STOCKPILE EROSION CONTROL PLANS
THE COMMONS AT FALCON FIELD
SECTION 7, TOWNSHIP 13 SOUTH, RANGE 64 WEST OF THE 6TH P.M.
PEYTON, EL PASO COUNTY, COLORADO

STOCKPILE EROSION CONTROL PLANS FOR:
**THE COMMONS AT
FALCON FIELD**
12445 RIO LANE, AND VACANT LAND
PEYTON, EL PASO COUNTY, COLORADO

ISSUE	DATE
INITIAL ISSUE	12/4/24

CVR

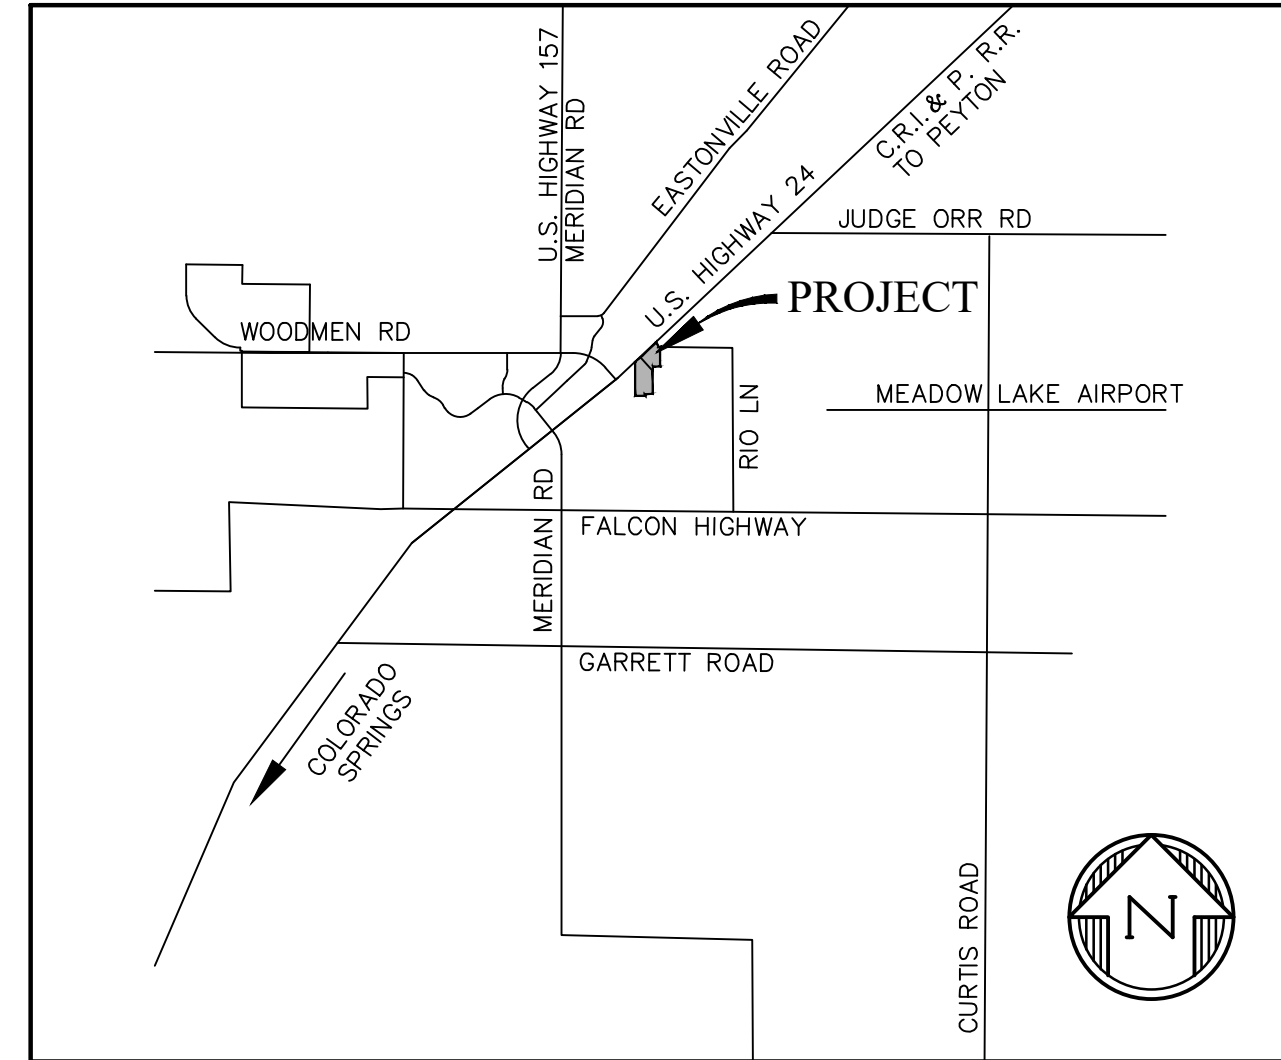
Replace with Checklist Note 17

this does not seem to be up to date. can put N/A instead of the soils report in the blank of this note.

EC-1

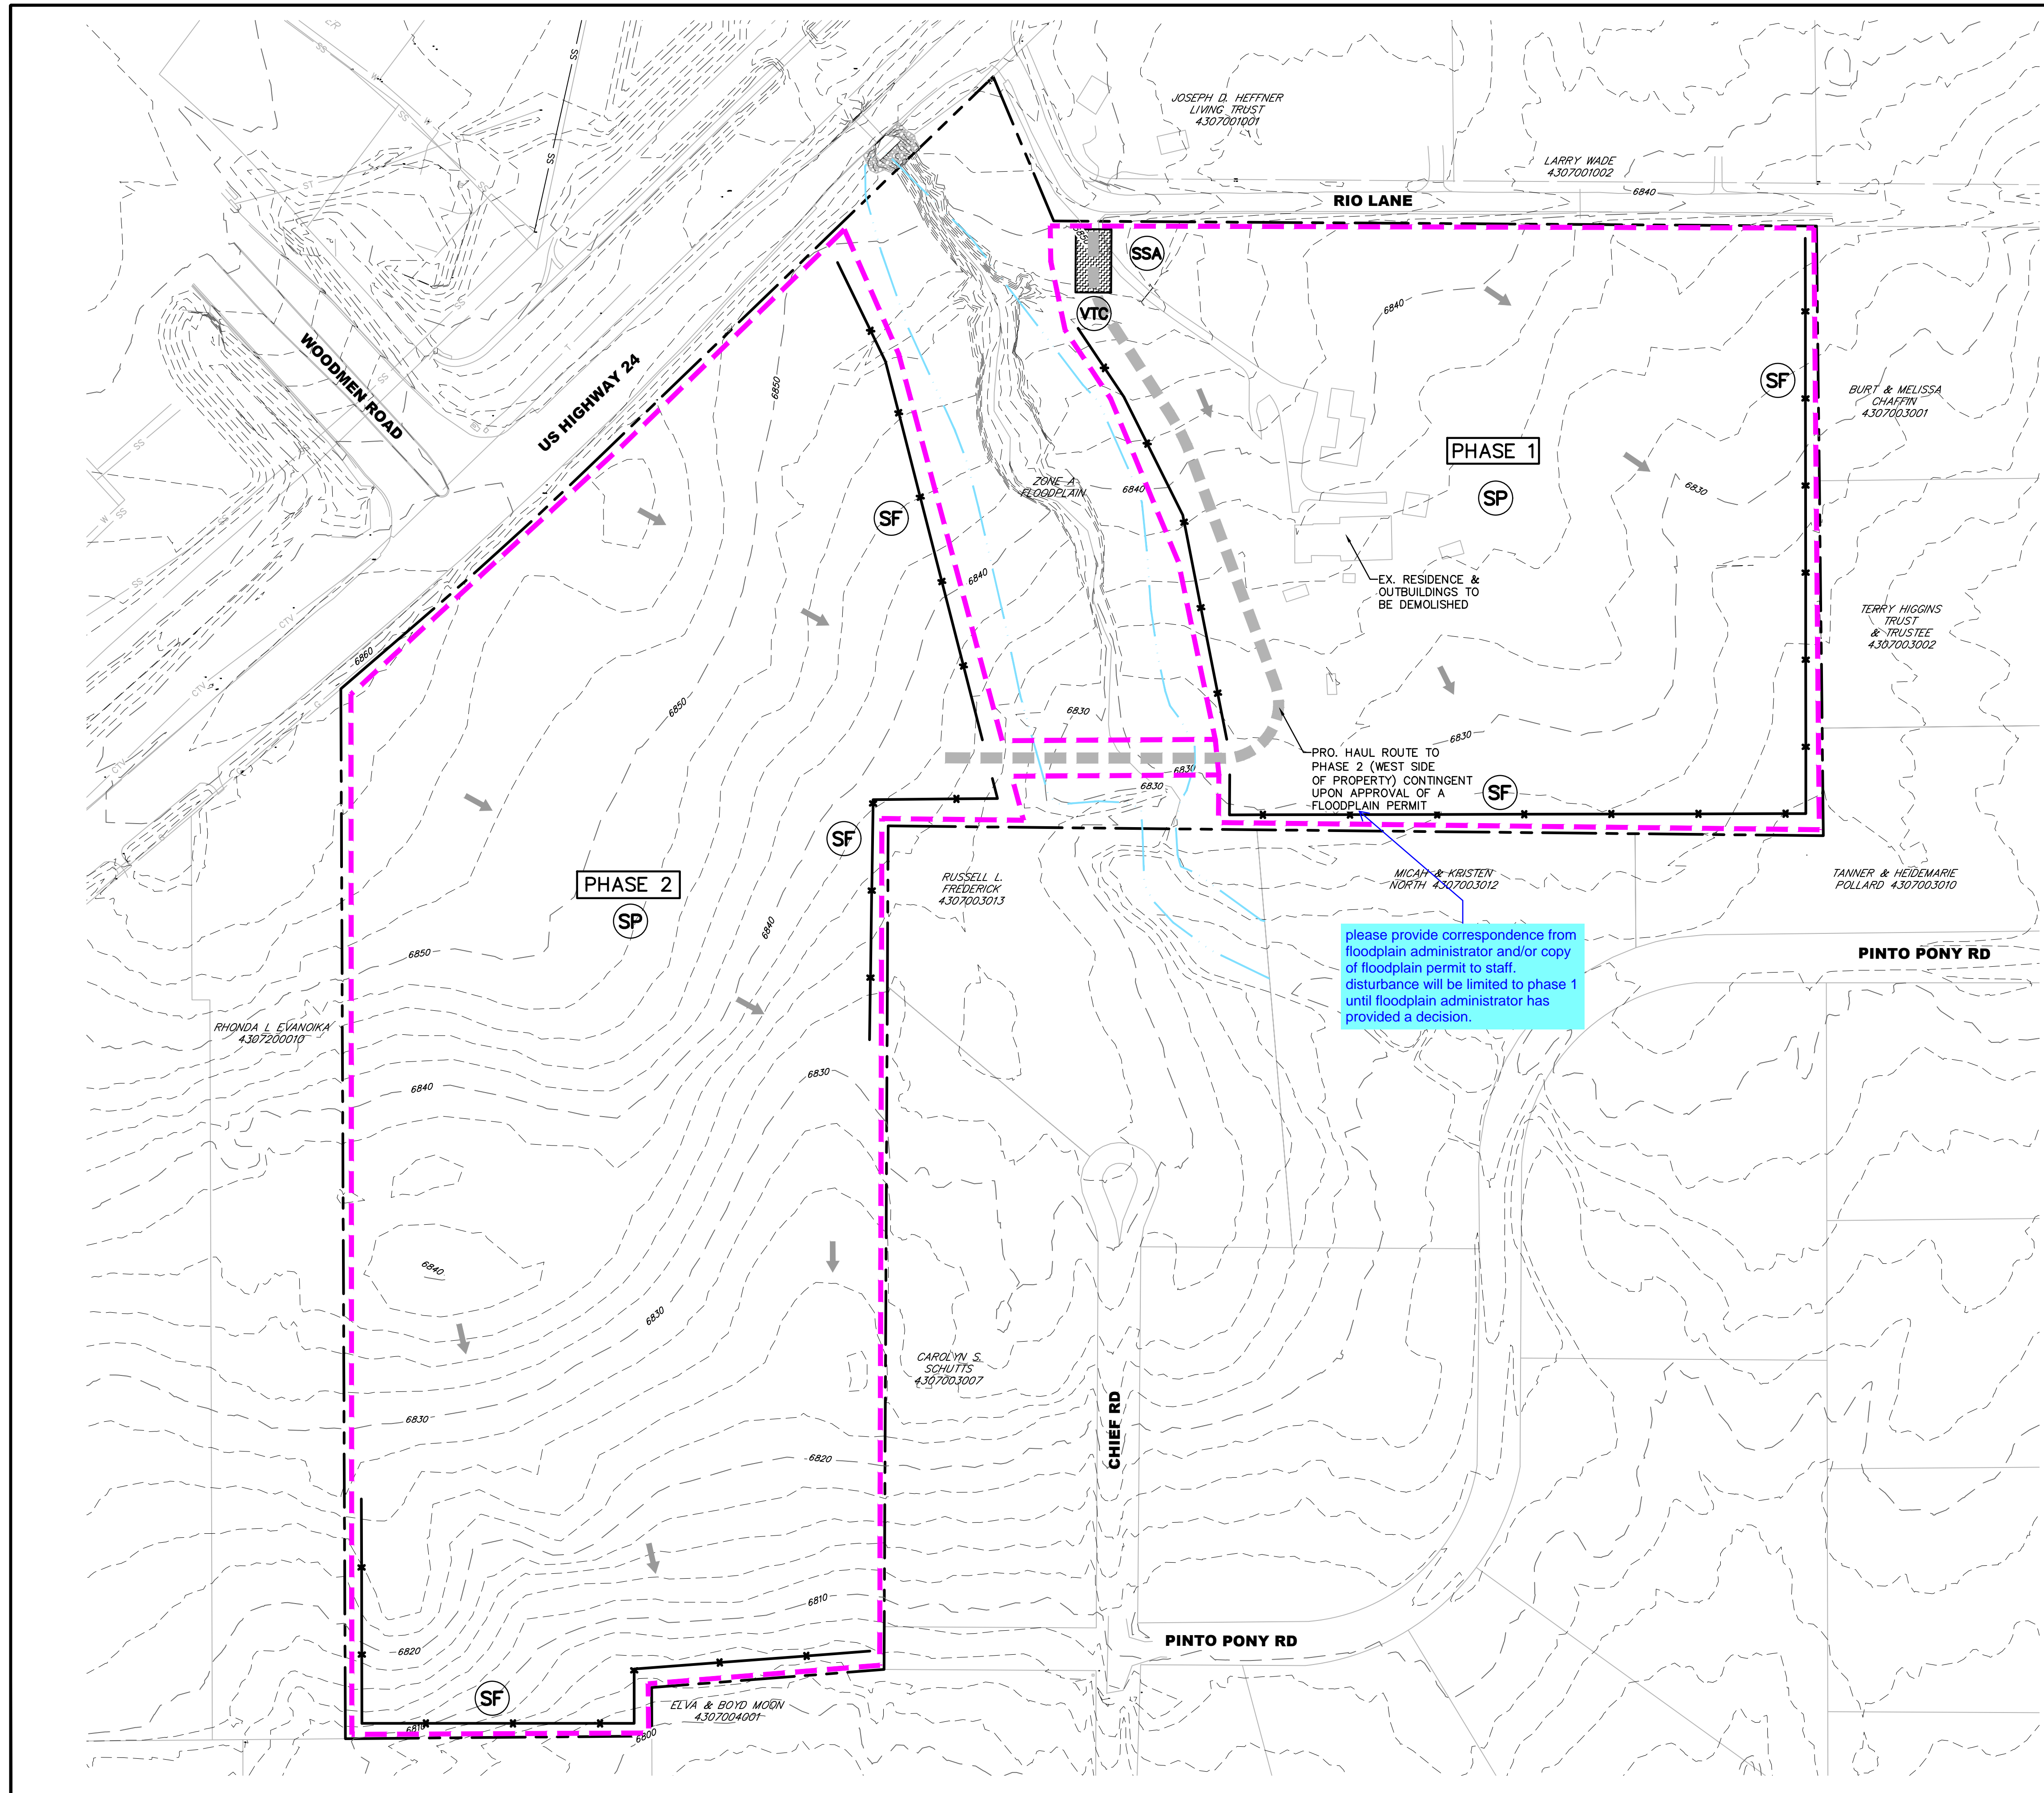
Show approximate limits for stockpiles and existing stockpile. See CDR2312 for an example of a GEC Plan for stockpiles only. The plans should show show temporary sediment basins for the disturbed and stockpile areas and diversions swales/berms to convey the runoff to TSBs. (TSBs are required for all disturbances greater than 1 ac) The plans need to show more detail for the general proposed design even if stockpiles exact locations may change. In example: how many stockpiles are anticipated, 1 large one? 10? 20? How large do diversion swales need to be? How many diversion swales are anticipated? Where will outfalls be located for TSBs and how will the downstream be protected?

- Seeding and mulching should be a BMP shown in the legend and on the plans.
- NOTES:
1. THE EXISTING RESIDENCE, ALL OUTBUILDINGS AND UTILITY SERVICES ARE TO BE REMOVED.
 2. EXISTING VEGETATION CONSISTS OF NATIVE SPARSE GRASSES AND SHRUBS.
 3. PRE-EXISTING VEGETATION TO BE MAINTAINED WITHIN 50-FT OF THE EXISTING TRIBUTARY.
 4. NO OFFSITE GRADING WILL OCCUR.
 5. NO ASPHALT/CONCRETE BATCH PLANTS WILL BE LOCATED ONSITE.
 6. EXISTING DRAINAGE PATTERNS ARE TO BE MAINTAINED.
 7. ACCESS TO THE SITE IS OFF RIO LANE ONLY. ONLY ACCESS TO WEST SIDE OF THE PROPERTY (PHASE 2) IS VIA HAUL ROUTE IDENTIFIED ON THIS PLAN AND IS CONTINGENT UPON APPROVAL OF A FLOODPLAIN PERMIT.
 8. NO DEWATERING IS ANTICIPATED.
 9. EROSION CONTROL BLANKET REQUIRED WHERE DISTURBED SLOPES EXCEED 3:1

please provide correspondence from floodplain administrator and/or copy of floodplain permit to staff. disturbance will be limited to phase 1 until floodplain administrator has provided a decision.

soil stockpile detail shows slopes can be greater than 3:1. Provide estimates for ECB and details for ECB.

GEC Checklist item v - all proposed TCMs should be labeled as initial interim and final.

DTL

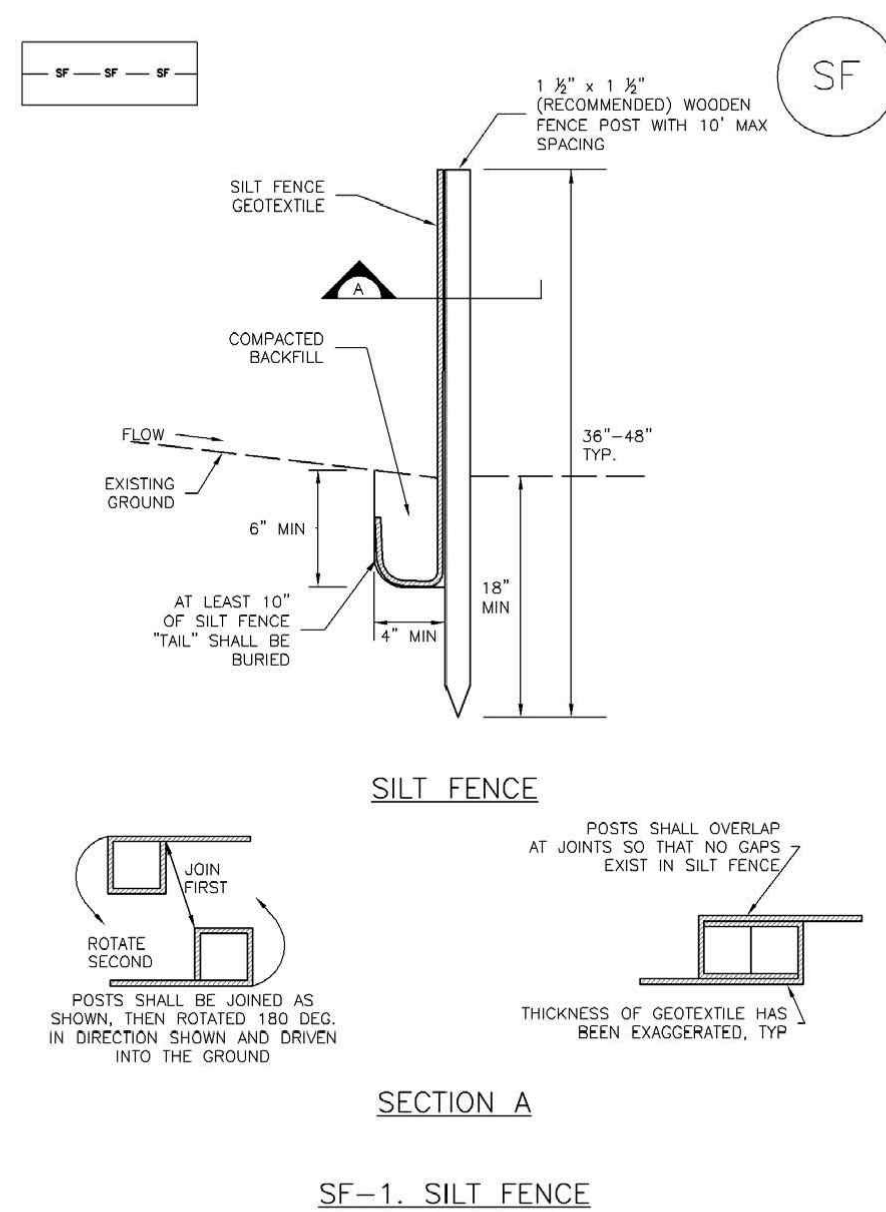
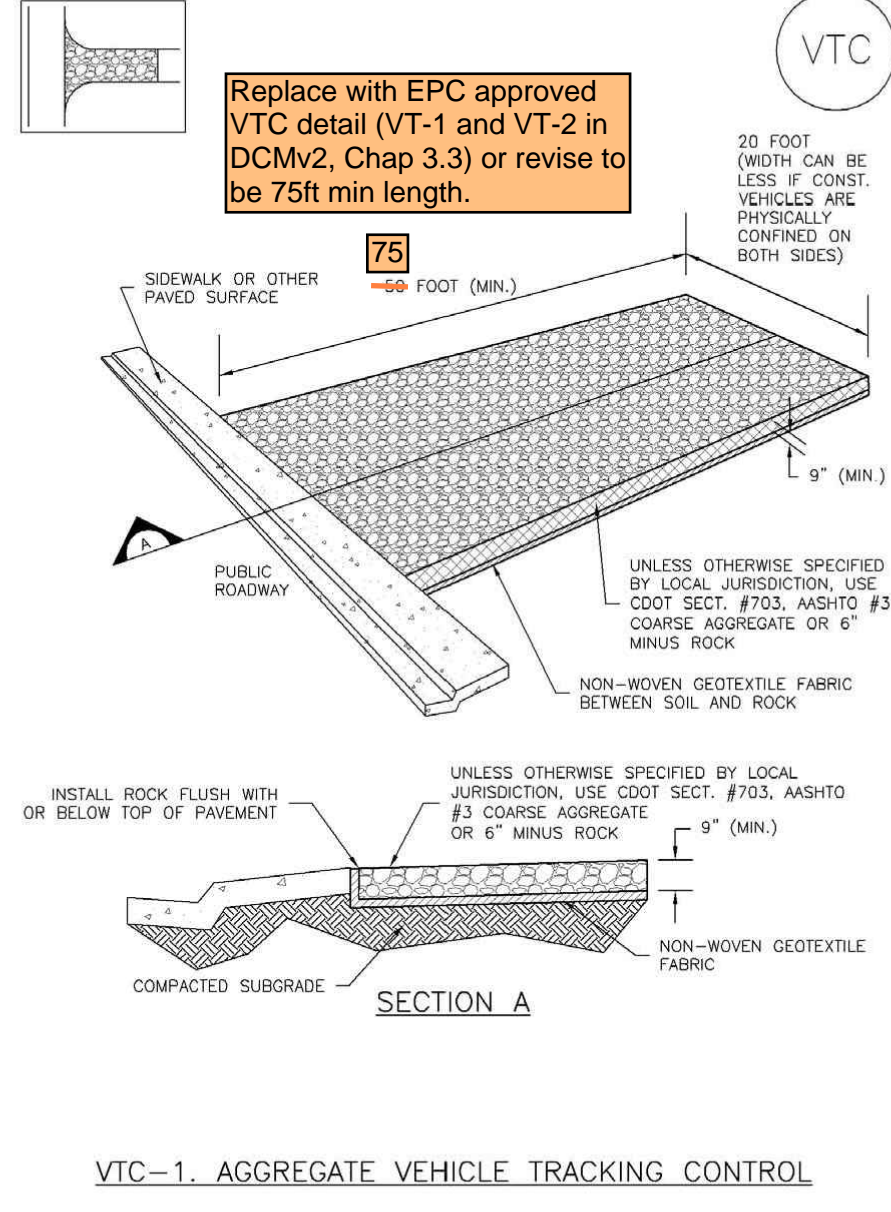
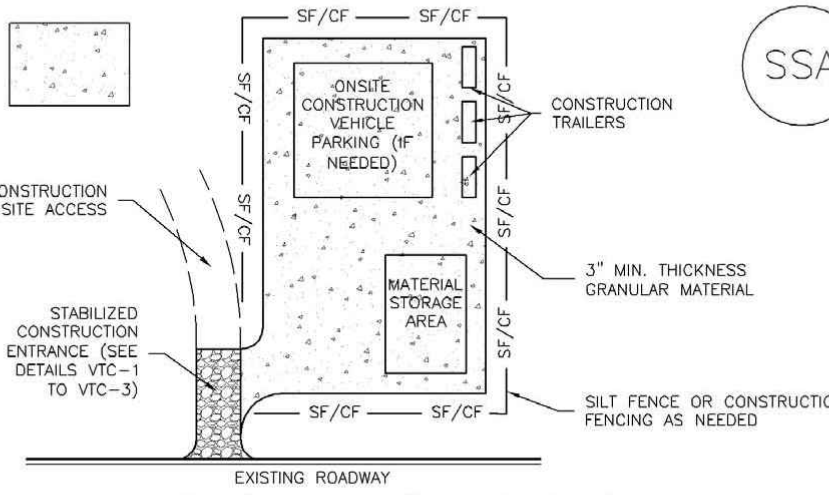
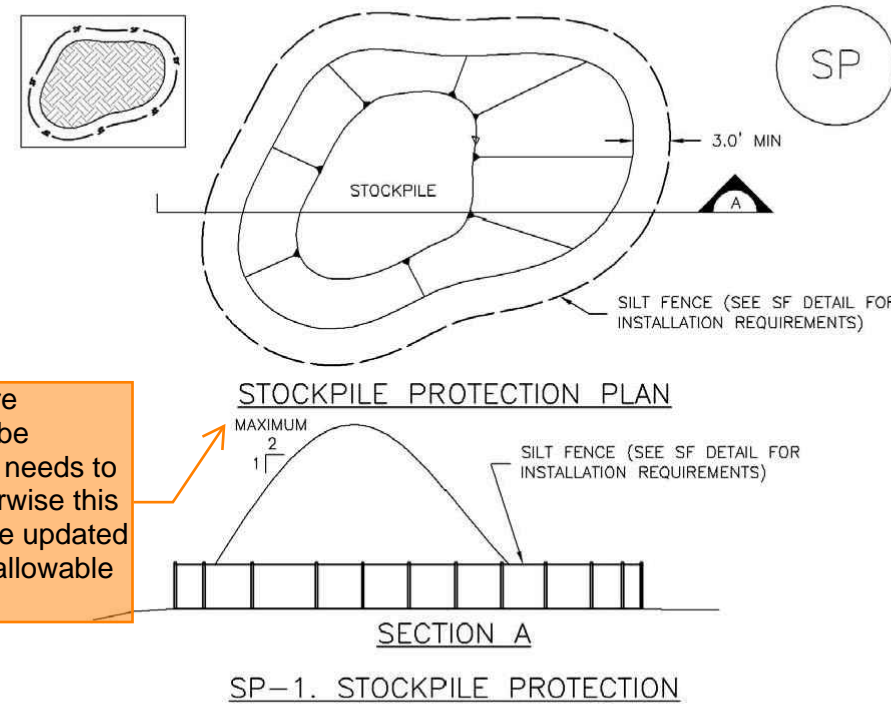
GEC Checklist Item z - provide details for seeding/mulching including seed mix.
